|  | Tender Questions and Answers | Document Identifier 240-7124948 | Rev 1 |

| Request for Enquiry Number | <u>E1934GXPLPMEDR</u> |
| Description / Project Title | PRIMARY AND SECONDARY CLARIFIERS VALVE AUTOMATION AT MEDUPI POWER STATION PROJECT FOR (TWELVE) 12 MONTHS. |

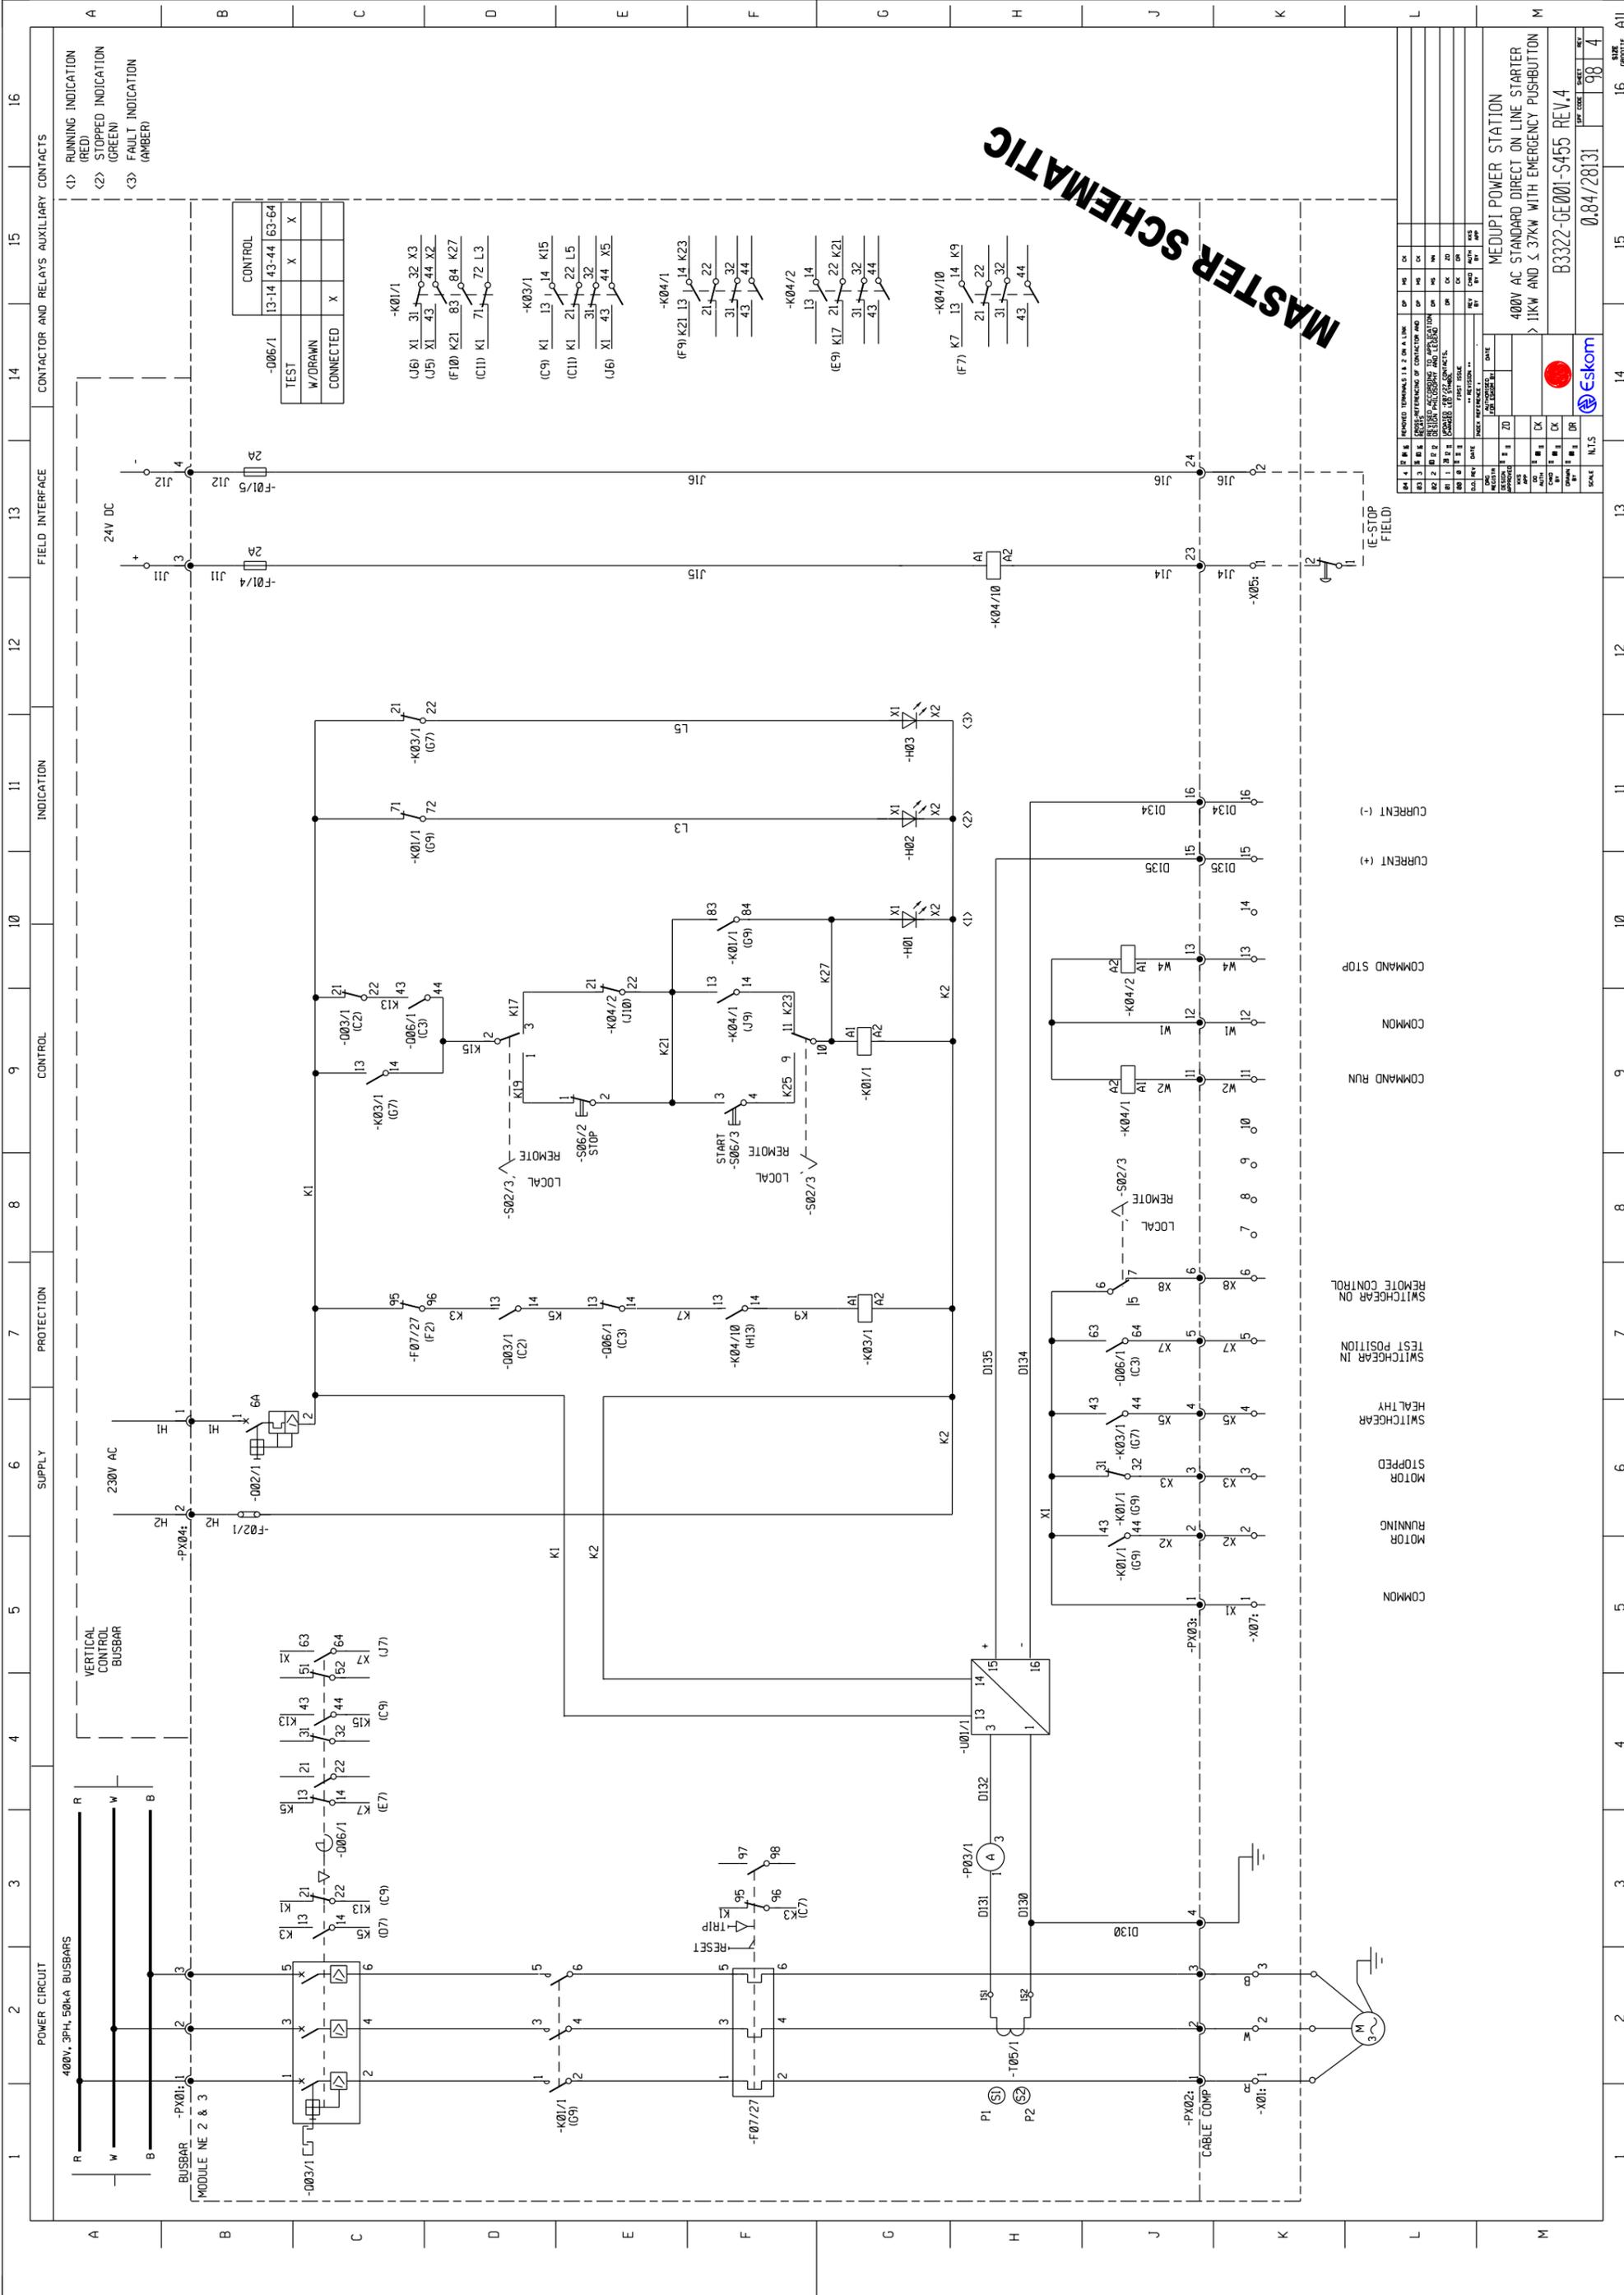
| 2. | <ul style="list-style-type: none"> • P&IDs (0.84/26148 SHT 1 and 0.84/26150 SHT 1, as per section 2.1.1 the SoW; • List of all OEMs names as per component/equipment, this will assist us in receiving quotes and ensure that we price from first principles • Reference to section 2.1.5.1, Table 5; Section 2.1.9, Table 8; Section , Section 2.1.10, Table 9, ERI require pipe thickness for us to source quotations • Mechanical Design pack for the existing works | <ul style="list-style-type: none"> • Requested P&ID attached • Auma for Actuators, WEIR'S for pumps. • Pipe Work Details attached • Please elaborate specifics | 26 January 2026 |
